Maharashtra Metro Rail Corporation Limited
(A joint venture of Govt. of India & Govt. of Maharashtra)
Nagpur Metro Rail Project - Phase 2

Corrigendum-II

Tender No: N2-010/C-04/2023 dated 07-Sep-2023

Name of Work: Design and Construction of Elevated Metro Viaduct of length 5.333 km between Ch. (-)289.668 m to Ch. (-)5622.577 m in Reach 4A of NMRP Phase-2

KAPSI KHURD / TRANSPORT NAGAR

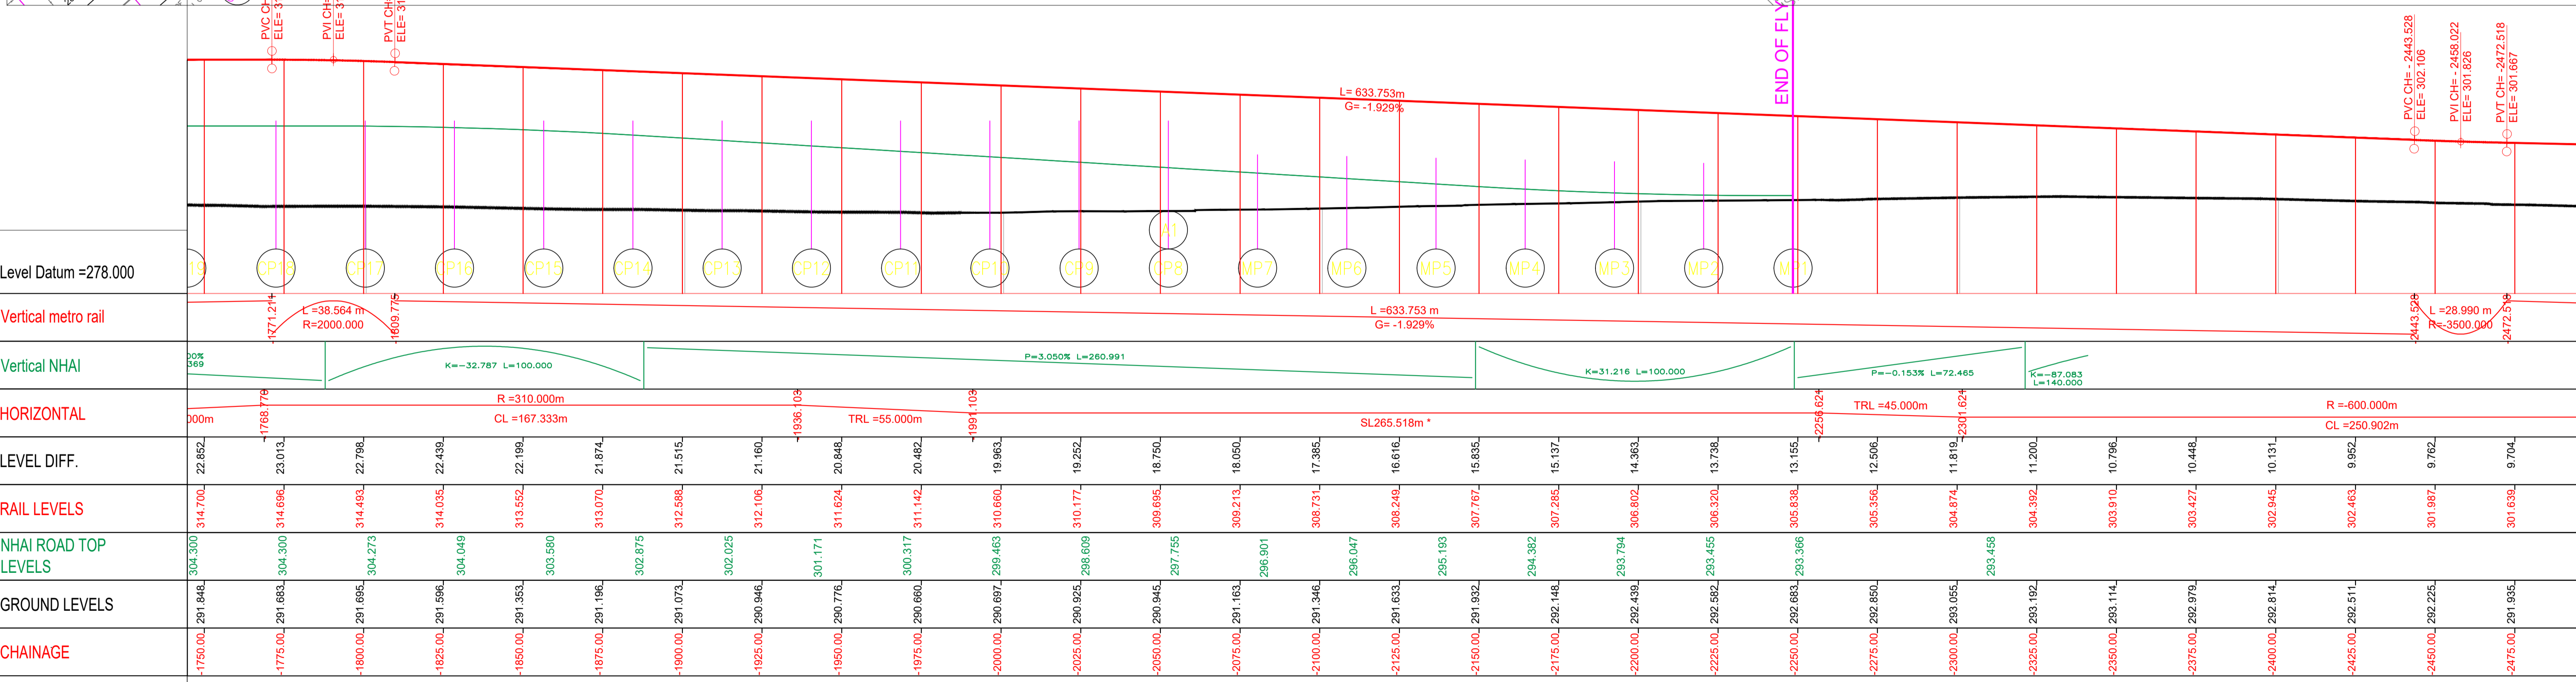
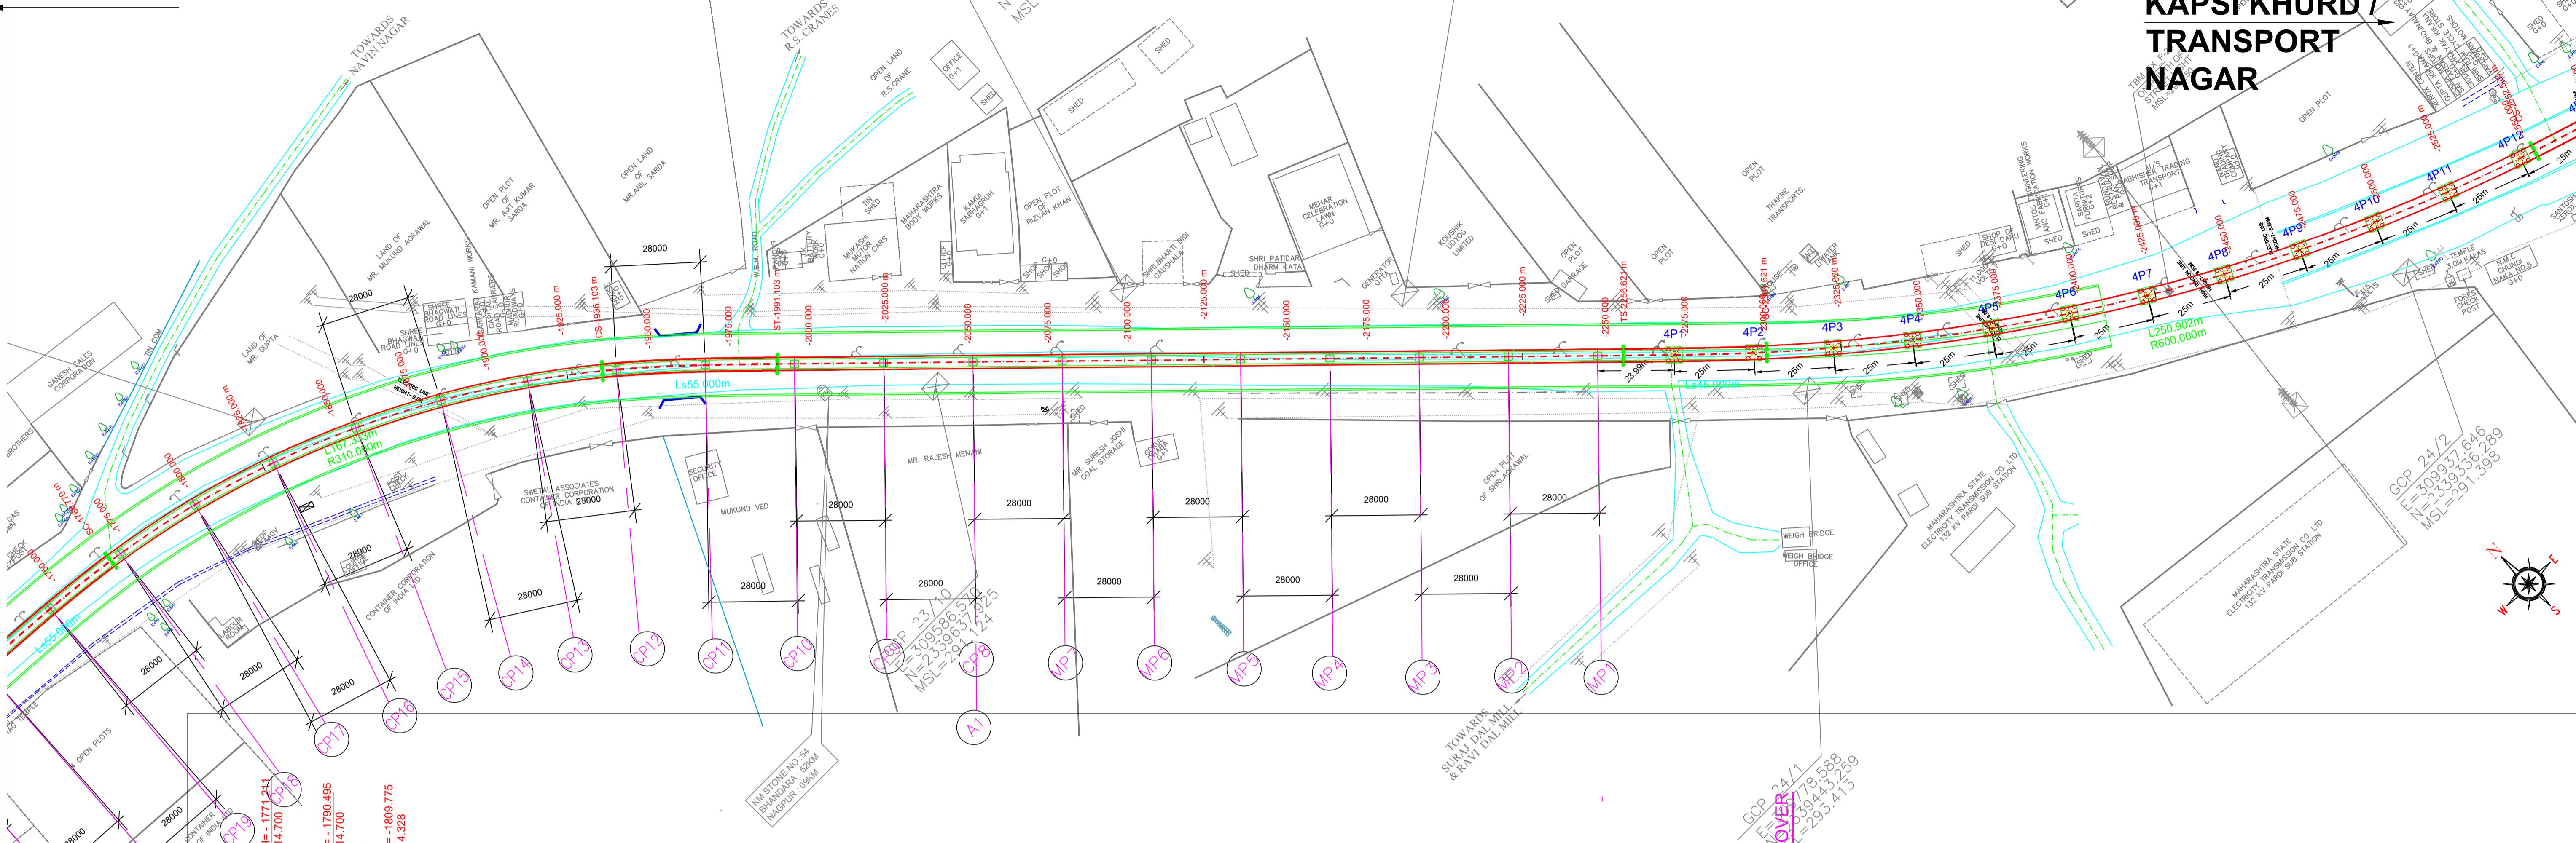
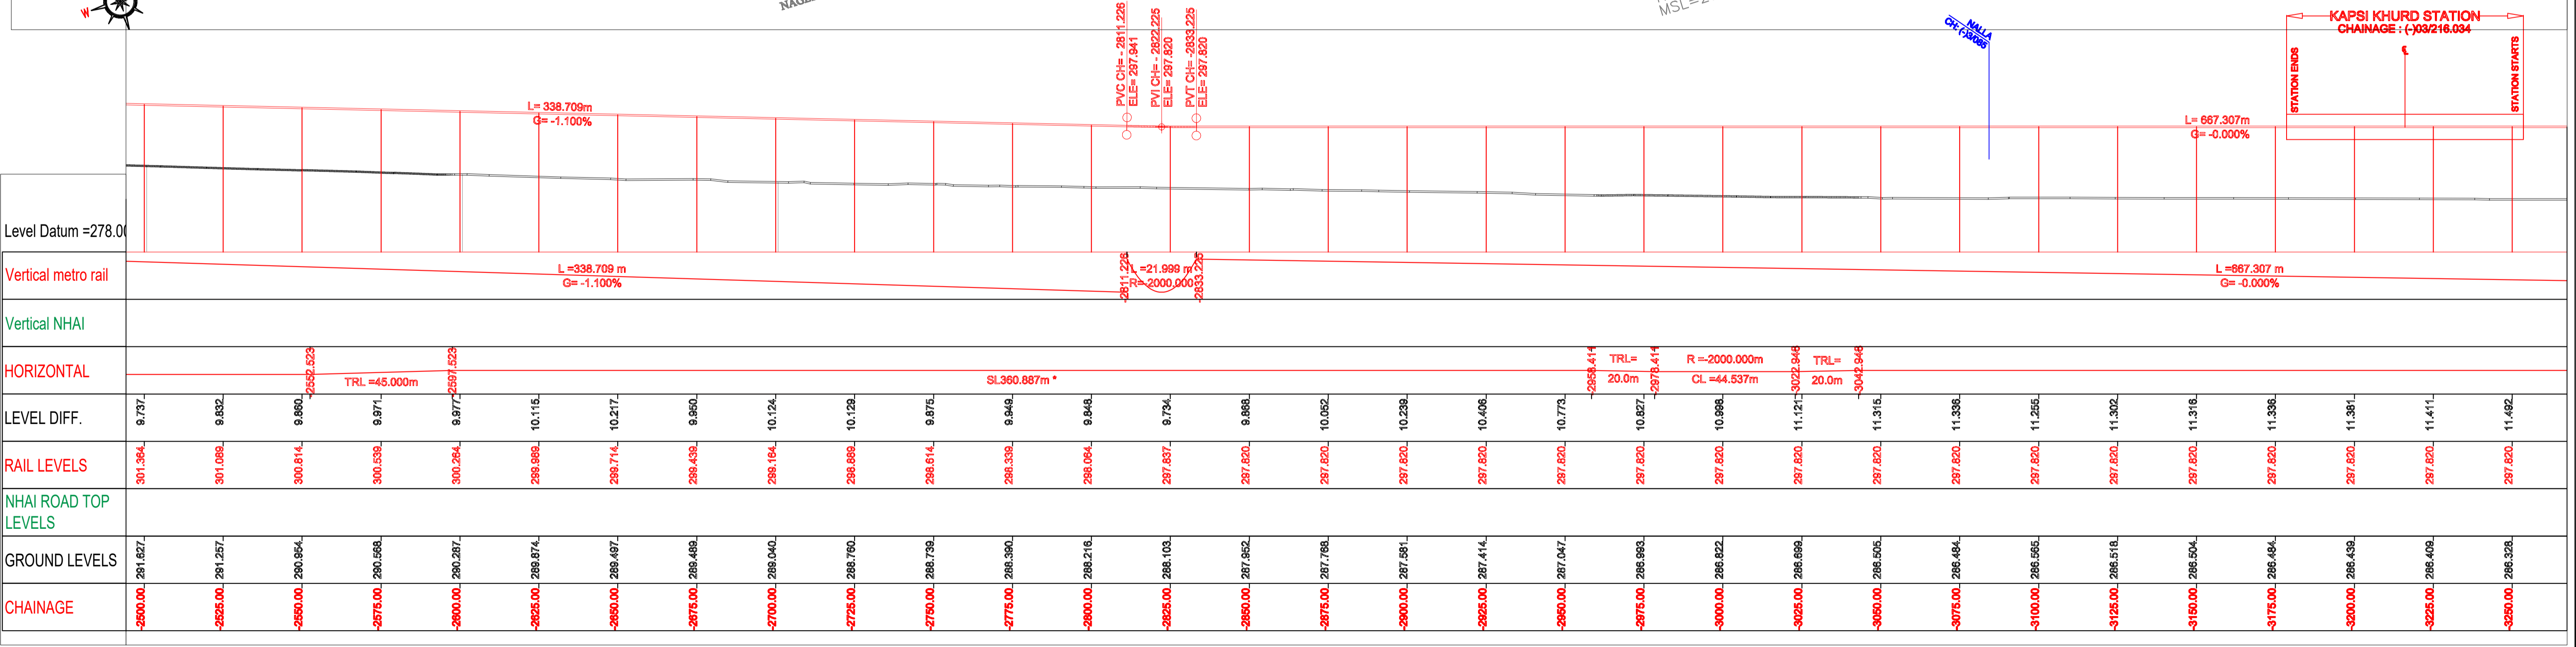
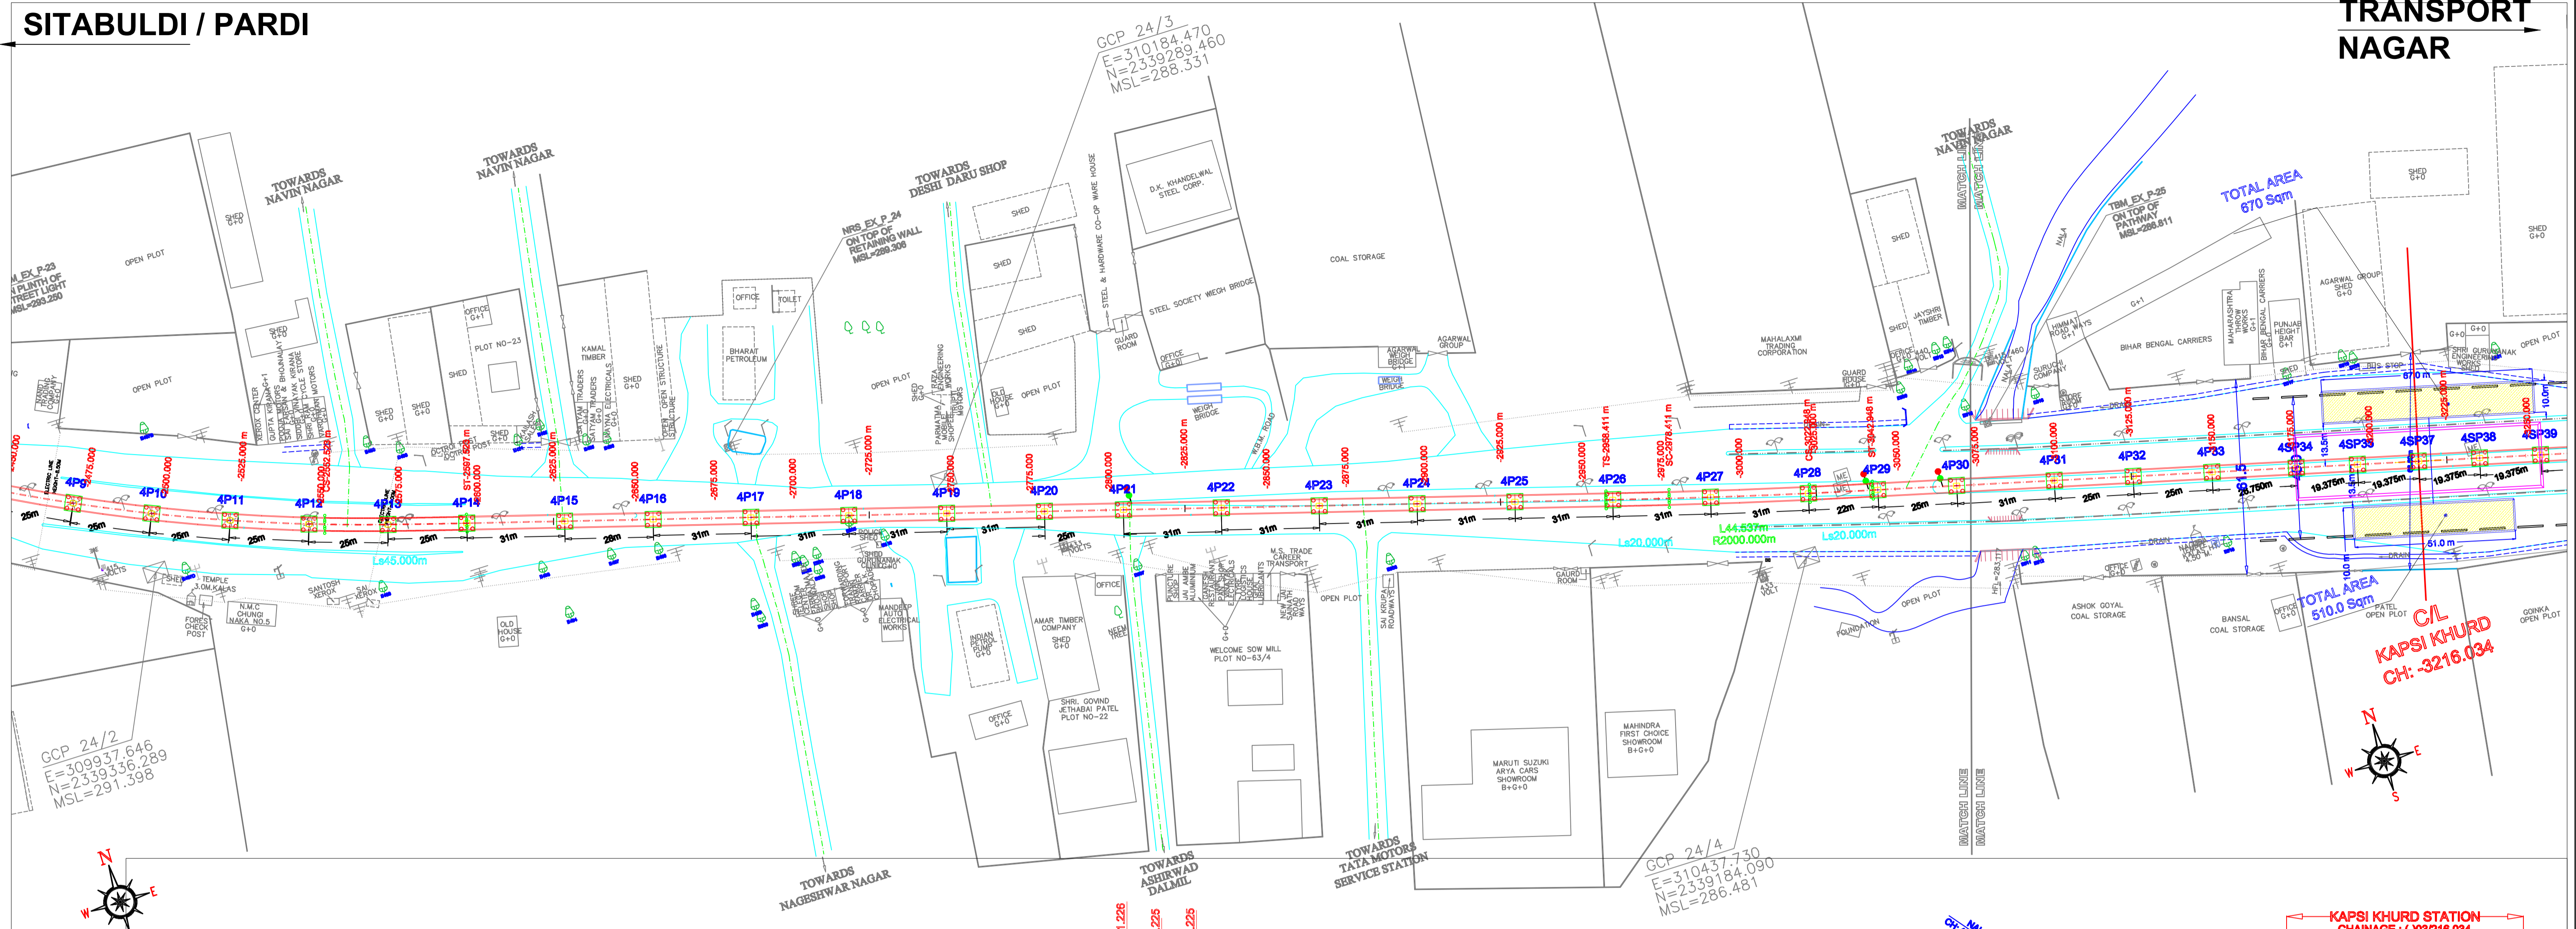
| Reference | Existing Provision | Revised Provision |
|--|---|---|
| Note no. 2 in GAD | Vertical profile as indicated in this tender drawing is based on GL/Road Level as surveyed during preparation of DPR in 2018. However, Contractor will have to ascertain its final value and maintain the requisite vertical clearance of 5.5m from existing/finished Road top level (as on date) to soffit level of Metro Superstructure. | Vertical profile as indicated in the tender drawing is based on GL/Road Level as surveyed during preparation of DPR in 2018. Maha-Metro Doesn't own any responsibility for the accuracy of the same, Contractor will have to ascertain its final value and maintain the requisite minimum vertical clearance of 5.5m from as built flyover Road top level (as on date of construction) in consonance with provision of IRC: 86-2018 from CH: (-)289.668 to (-)2250.000. Also, From CH: (-)2250 to CH: (-) 5560.827 shall maintain minimum vertical clearance of 5.8m from the existing road level. |
| GAD DWG NO. MM/PIg/NIT/NGP PH-II/4A/R1/2023 | GAD - DWG NO. MM/PIg/NIT/NGP/PH-II/4A/R1/2023 (Sheet 1 to 8) dated 12-July-23 | Revised Drawings are attached with this corrigendum: GAD - DWG NO. MM/PIg/NIT/NGP/PH-II/4A/R2/2023 (Sheet 1 to 8) dated 26-Oct-23 |
